PROPOSAL FOR DRAFT AMENDMENTS TO REGULATION No. 37

(Filament lamps)

Transmitted by the expert from the Working Party "Brussels 1952" (GTB)

Note: The text reproduced below was prepared by the expert from GTB in order to introduce a new filament lamp category W15/5W. It is based upon Regulation No. 37 up to and including Supplement 25 to the 03 series of amendments. The modifications to the existing text of the Regulation are marked in **bold** characters.

**FILAMENT LAMP FOR MOTORCYCLES**

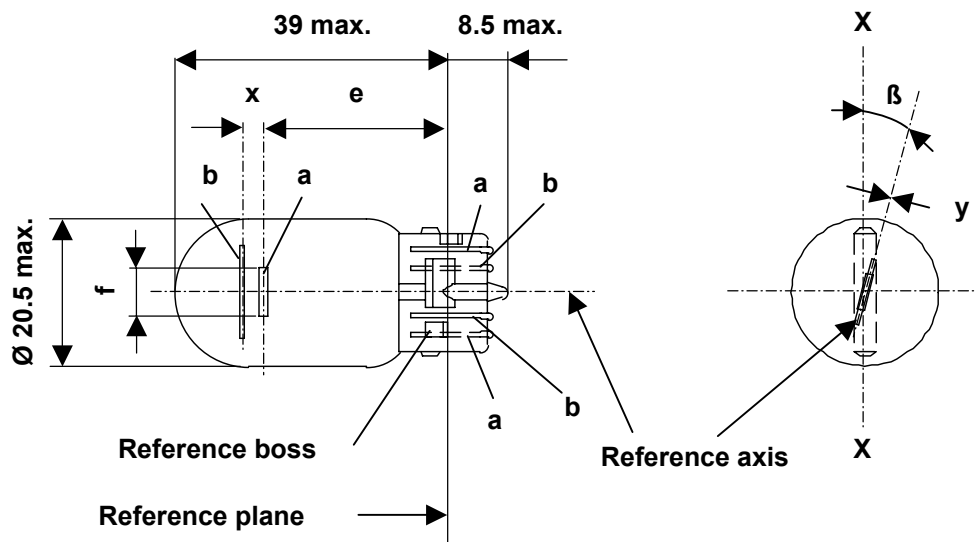
Insert new sheets W15/5W/1 to 3, between sheet W5W/1 and sheet W16W/1 as indicated in the list of sheets above, to read: (see next pages).

**Screen projection requirements**

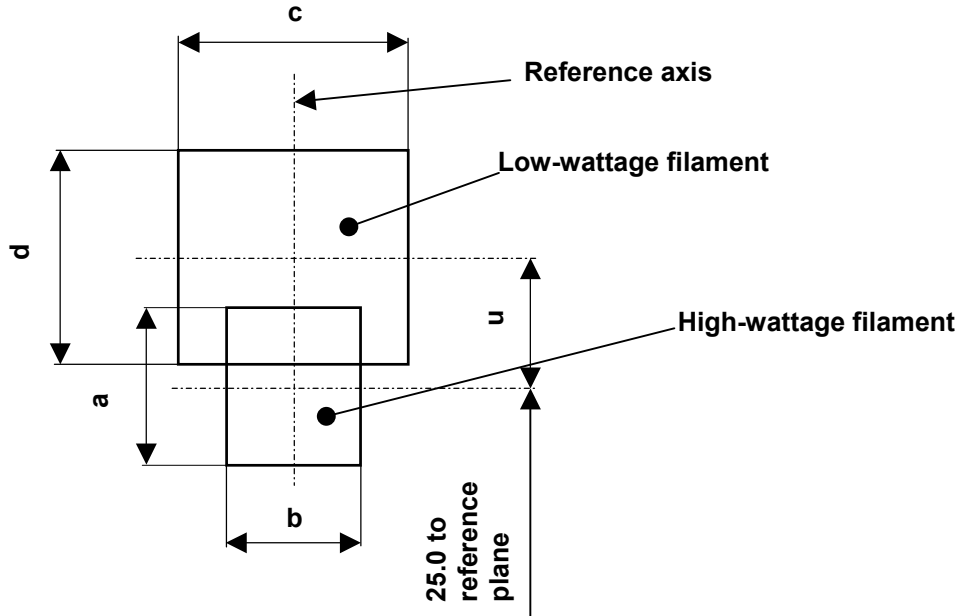
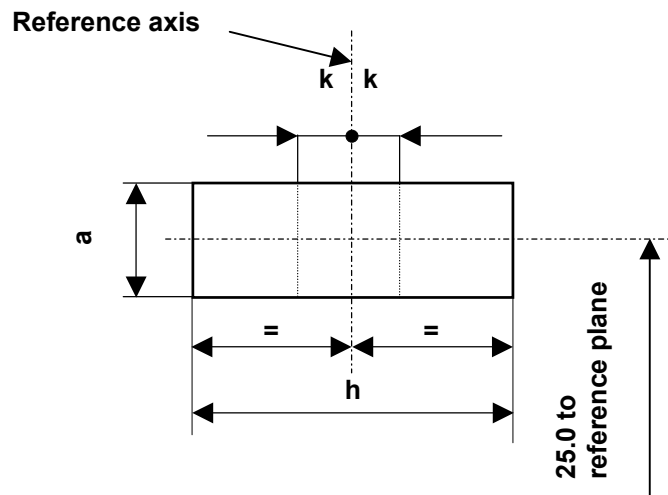
- (a) the major filament is correctly positioned relative to the reference axis and reference plane and has an axis perpendicular, within  $\pm 15^\circ$ , to the plane through the axis X-X and the reference axis; and whether:
- (b) the minor filament is correctly positioned relative to the major filament, whether a filament lamp complies with the requirements.

2. Side elevation  
The filament lamp placed with the cap down, the reference axis vertical and the major filament seen end-on:
  - 2.1. the projection of the major filament shall lie entirely within a rectangle of height "a" and width "b", having its centre at the theoretical position of the centre of the filament;

- 2.2. the projection of the minor filament shall lie entirely within a rectangle of width "c" and height "d" having its centre at a distance "u" above the theoretical position of the centre of the major filament.

3. Front elevation  
The filament lamp being placed with the cap down and the reference axis vertical, the filament lamp being viewed in a direction at right angles to axis of the major filament:

- 3.1. the projection of the major filament shall lie entirely within a rectangle of height "a" and width "h", centred on the theoretical position of the centre of the filament;

- 3.2. the centre of the major filament shall not be offset by more than distance "k" from the reference axis.
  - 3.3. the centre of the minor filament axis shall not be offset from the reference axis by more than  $\pm 2$  mm ( $\pm 0.4$  mm for standard filament lamps).
